## MIDLAND BAY LANDING

### RISK ASSESSMENT

**420 Bayshore Drive, Midland, Ontario**

*Project No. 2960*

Figure 4.1 Human Health Conceptual Site Model – Without Risk Management (Revised)

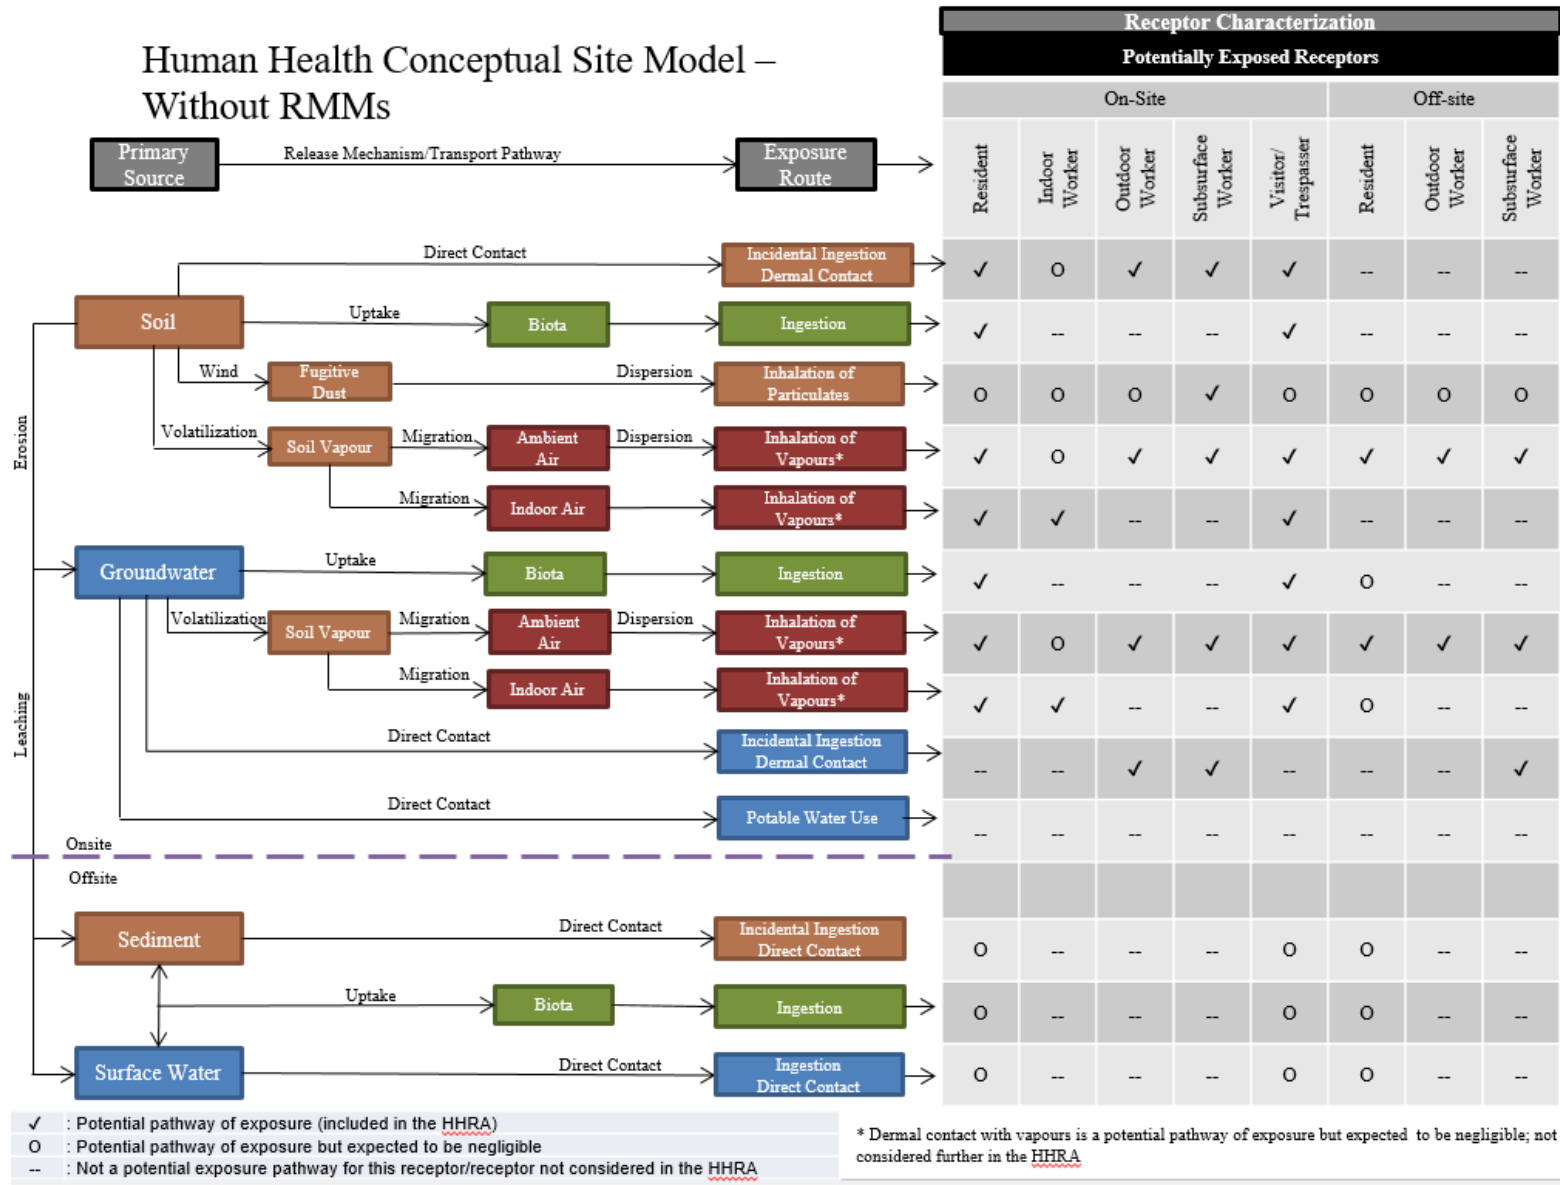
- b. Given that the soil direct contact pathways for the resident receptor are identified as complete in Figure 4.1 (Human Health Conceptual Site Model – Without Risk Management) and the REMCs for a number of soil COCs exceeded their respective S1 component value, it is unclear why the 'hours exposed per day – outdoor' for the resident receptor is 'NE – not evaluated'. This discrepancy should be clarified.

the same exposure pathways as the resident (in response to comment table and in updated Table 4.1), however the HH CSM (Figure 4.1) still indicates that exposure pathways will be negligible. It is unclear where the QP has documented the justification for negligible exposure since there is no section identifying the Visitor characteristics that explain why exposure is negligible. The QP will have to address this discrepancy.

13a	Section 4.1.1 – Human Health Conceptual Site Model	The on-site receptors identified in the text should be consistent with the Human Health Conceptual Site Model figures. For consistency and completeness, Figures 4.1 and 4.2 (Human Health Conceptual Site Model – Without and With Risk Management) should be updated to include the trespasser.	The trespasser has been added to Figures 4.1 and 4.2.	Comment addressed	No response required

Figure 4.2 Human Health Conceptual Site Model – With Risk Management (Revised)

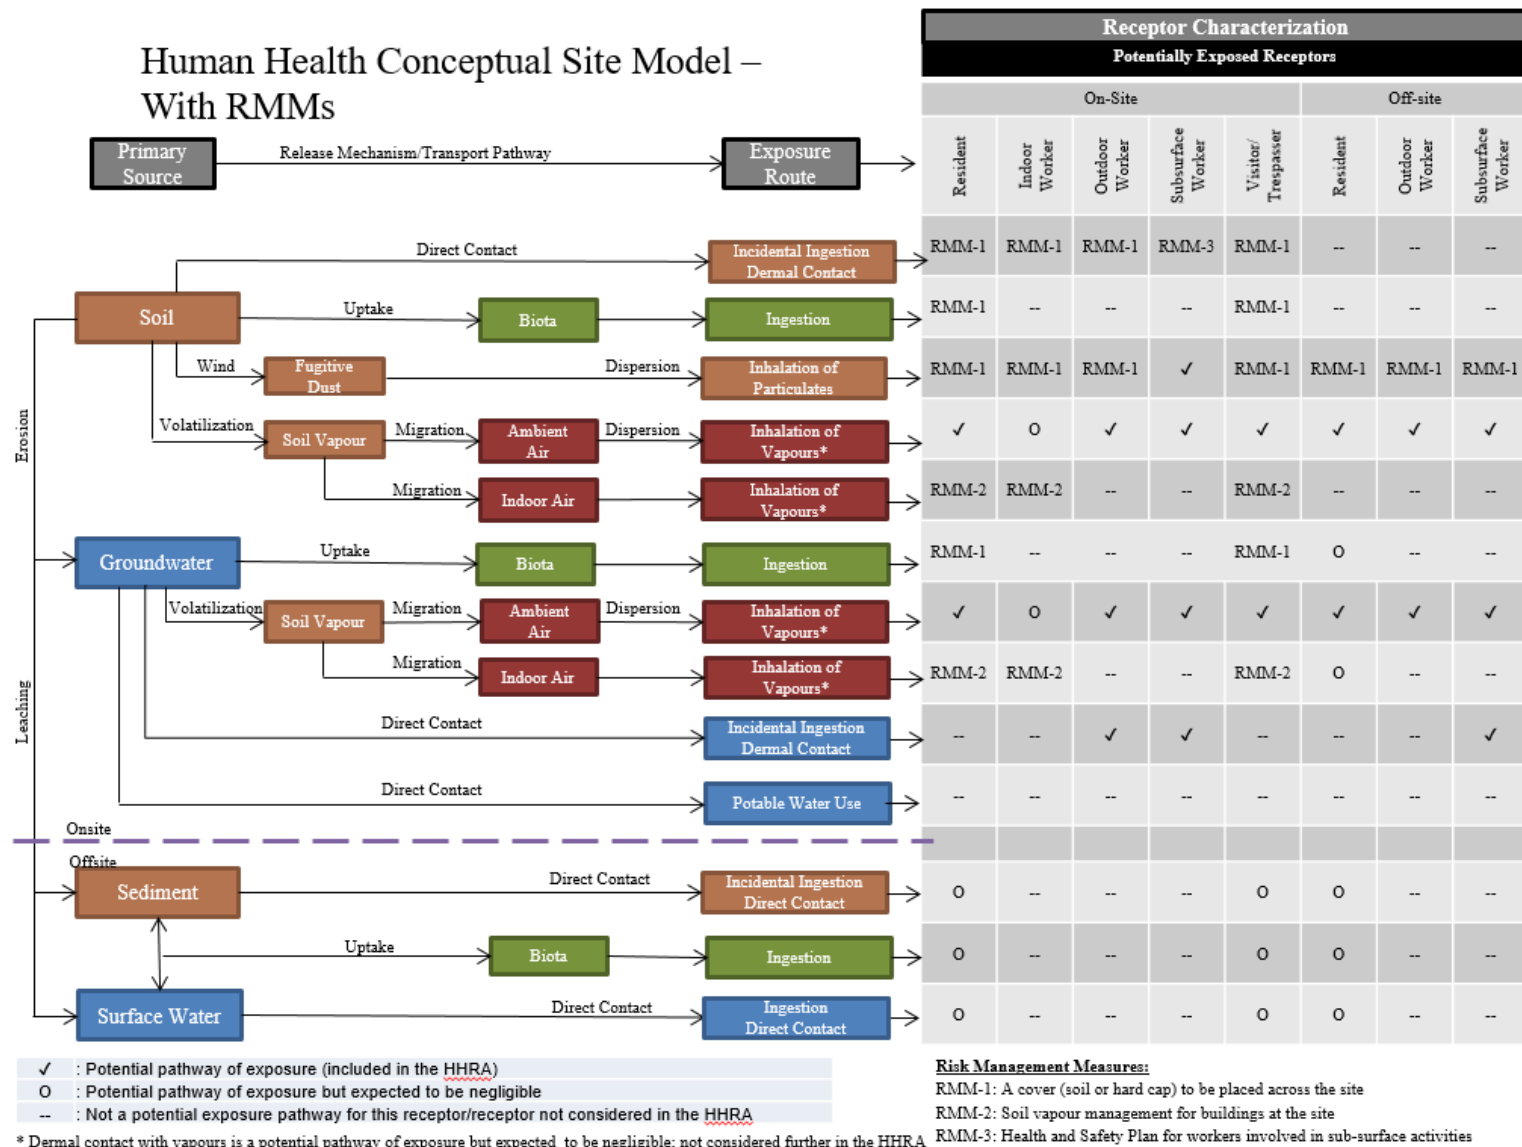
- a. The response is not accepted and additional comments have been provided below.
  - b. The response is accepted; however, Figure 4.2 has not been corrected and should be revised accordingly.

- b. **Figure 4.2 (Human Health Conceptual Site Model – With Risk Management).** The specific RMM (e.g., capping, HASP) proposed for each exposure pathway should be specified.

No.	Section/Area in Report	Ministry Comment (March 20, 2020)	Comments on Risk Assessment				
			Response	Ministry Comment (October 10, 2020)	Response	Ministry Comment (July 22, 2021)	Response
13b		Figure 4.2 (Human Health Conceptual Site Model – With Risk Management). The specific RMM (e.g., capping, HASP) proposed for each exposure pathway should be specified.	The CSMs have been updated to indicate which RMM is proposed for each exposure pathway	Comment addressed	No response required		
14a	Section 4.1.1.1 – Resident	The text incorrectly states that “no COCs were identified in groundwater”. Furthermore, the text has incorrectly identified vapour intrusion into indoor air is limited to soil COCs as a potential exposure pathway. Please review and revise this section as appropriate or justify why groundwater COCs are not considered for vapour intrusion.	This has been updated in the RA report.	Comment addressed	No response required

13. **Section 4.1.1 – Human Health Conceptual Site Model.**
  - a. Comment addressed.
  - b. **Figure 4.2 (Human Health Conceptual Site Model – With Risk Management).** Comment addressed.

**Figure 5.1 Ecological Conceptual Site Model – Without Risk Management (Revised)**

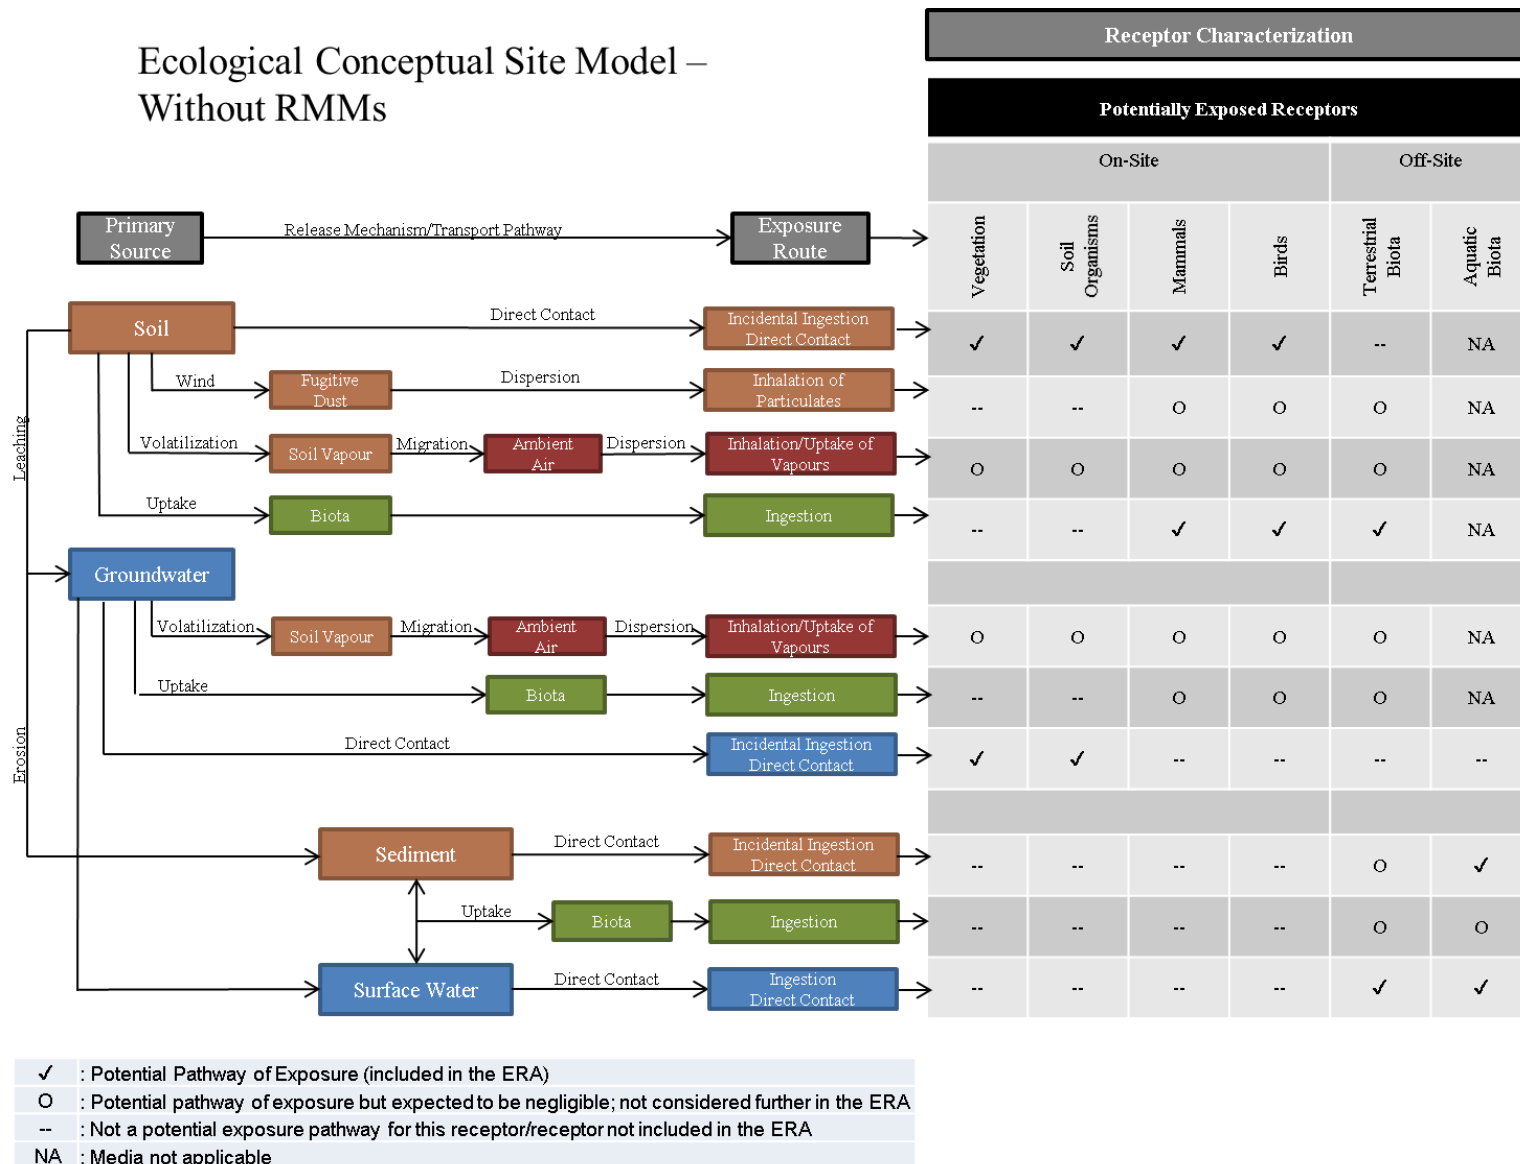
- b. Ingestion of soil by off-site terrestrial biota is not discussed in the text but is indicated as a potential pathway in Figure 5-1. This should be revised for consistency.

- b. These sections should be carefully reviewed and revised for consistency with the Eco CSM (Figure 5.1). Examples include that direct contact with groundwater by terrestrial plants and soil organisms is not included in Section 5.3.1.1; the second bullet in Section 5.3.1.1 refers to mammals and birds in the Terrestrial Plants and Soil Invertebrates section; bullets speak to stem and foliar uptake of vapours (sourced from volatile COCs in soil); Section 5.3.1.2 does not include direct contact by mammals and birds, etc

37b		Ingestion of soil by off-site terrestrial biota is not discussed in the text but is indicated as a potential pathway in Figure 5-1. This should be revised for consistency.	Ingestion of soil by off-site terrestrial is considered not a potential exposure pathway and is therefore not considered in the ecological risk assessment. It has been updated in the	Comment addressed	No response required		
38a	Section 5.1.2 – Contaminants of Concern for Ecological Receptors	It is not clear how the COCs listed in this section were determined. They do not appear to align with the COCs determined by Table 9 screening (presented in Table 3.4), or the secondary screening presented in Section 5.1.3. This should be clarified.	This section has been updated to include all COCs identified in Table 3.4	The response partially addresses the comment; it is not clear why vinyl chloride has been included as a COC in soil	Vinyl chloride is not included in Table 5.1 which is the table for COC in soil.	Comment not addressed. The list of COCs in soil presented in the text of Section 5.1.2 is different from the one presented in Section 3.3.2.1. The text of Section 3.3.2.1 does not list vinyl chloride as a COC, and the text of Section 5.1.2 does list vinyl chloride as a COC. The text should be clarified for consistency	The discussion in Section 5.1.2 is for soil and groundwater (as mentioned in the introduction sentence). Vinyl chloride is a COC in groundwater; however, vinyl chloride did not exceed the standard in soil, which is why it is not flagged as a COC in Section 3.3.2.1. Vinyl chloride is not included in Section 5.1.3, which is specific to soil. No change was made to the RA.
